Re: Proposed Hydro-electric Generating Station at the Bala Falls

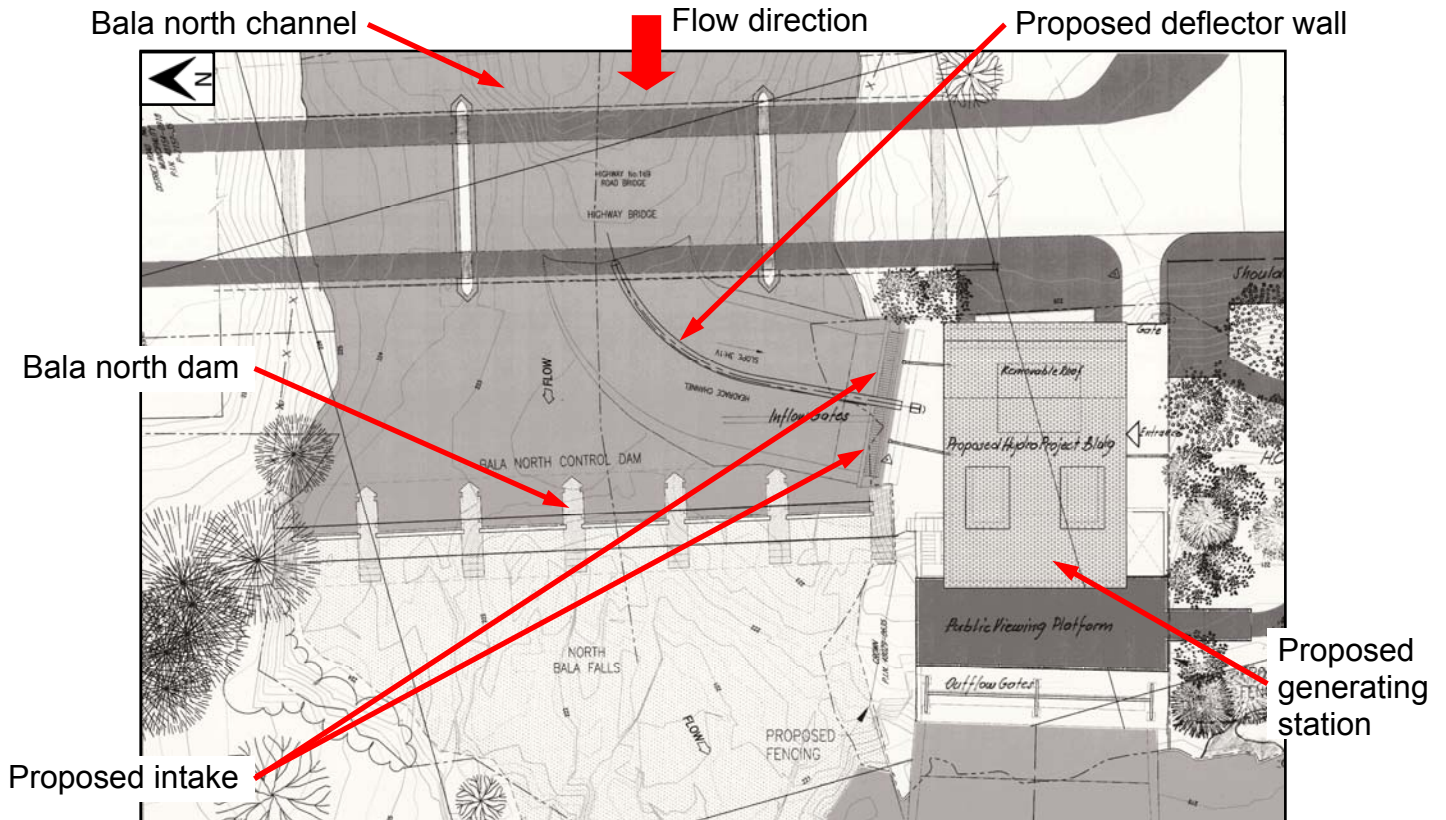
However, the proponent's drawings now show they would construct a concrete "*central deflector wall*" to direct flow into the intake of their proposed generating station. For example, the figure below is a section of a technical drawing the proponent currently has posted on their web site at <http://balafalls.ca/plans>

- The concern is that their proposed generating station could stop operation at any time. The proposed deflector wall would then be an obstruction to the flow through several of the Bala north dam's sluices. This obstruction would not comply with the MNR's Phase 1A approval under the LRIA.
- Such an obstruction would reduce the flow capacity through Bala, therefore increasing the risk that high flow events, such as during spring freshet, would flood Lake Muskoka and the thousands of private properties on it.

- Also, when the proposed generating station is not operating, this proposed deflector wall would cause the water to swirl at the east abutment of the District Municipality of Muskoka's Highway Bridge, causing erosion which could undermine the bridge.
